Development Application **ACCESS REPORT**

Reference Number: 23331

16 Terry Road, Eastwood NSW

The following drawings by Janssen Designs have been assessed for compliance.

[Image description: Plan of Basement level above shows the provision of Accessible parking spaces]

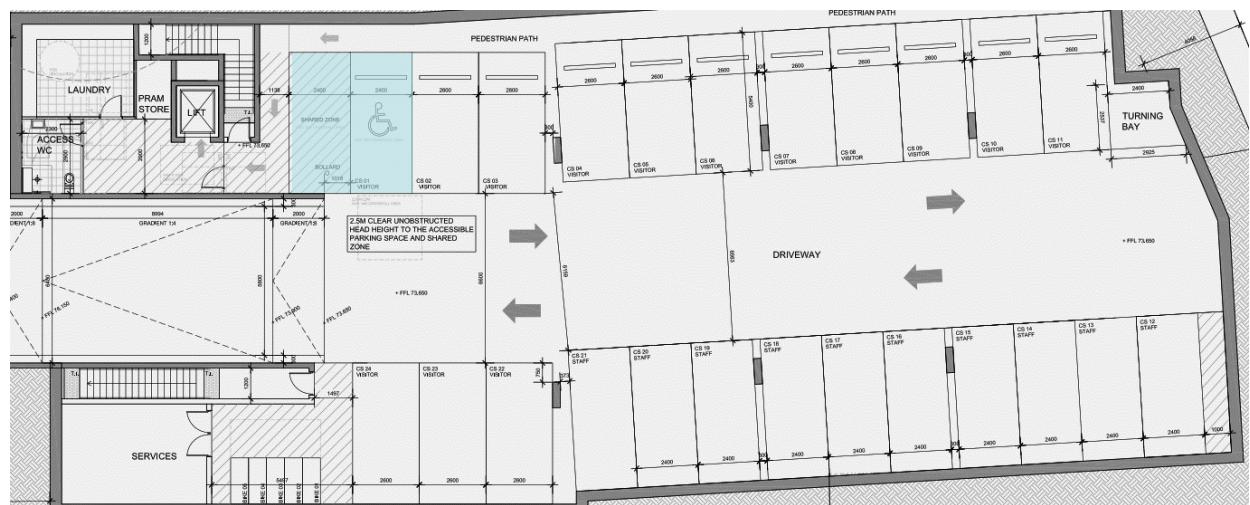
Total number of Accessible parking spaces required / provided in the development = 1

[Image description: Diagram showing spatial requirements of AS2890.6 including line marking, symbol and bollard requirements]

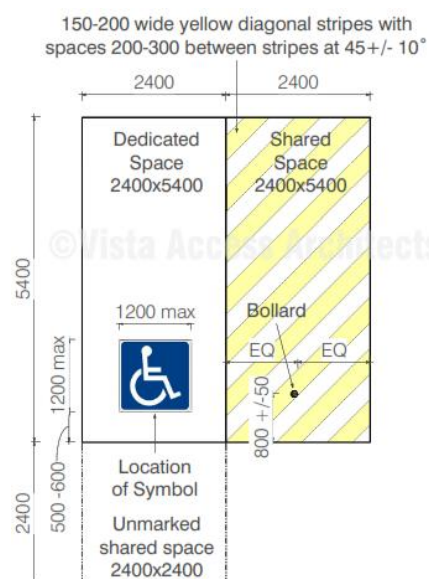
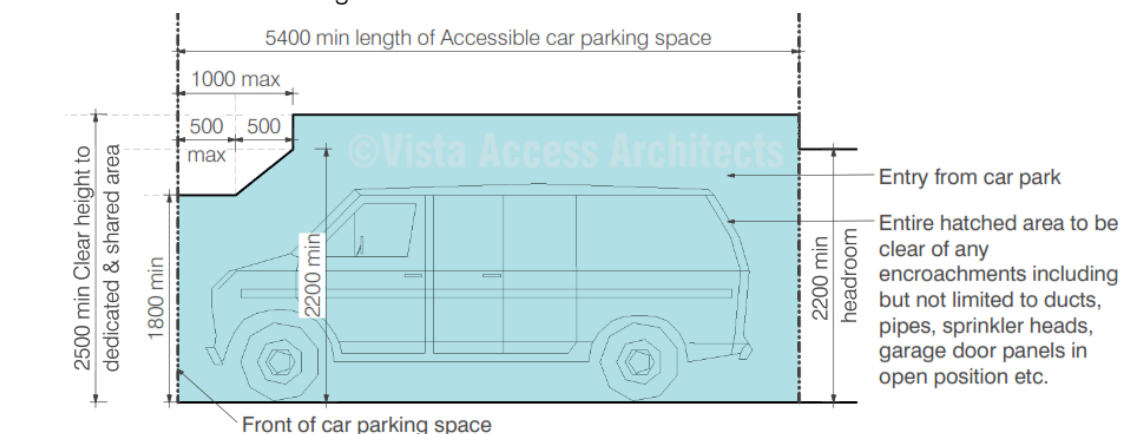
Bollard location to be moved at CC stage.
Details to be verified at CC stage of works.
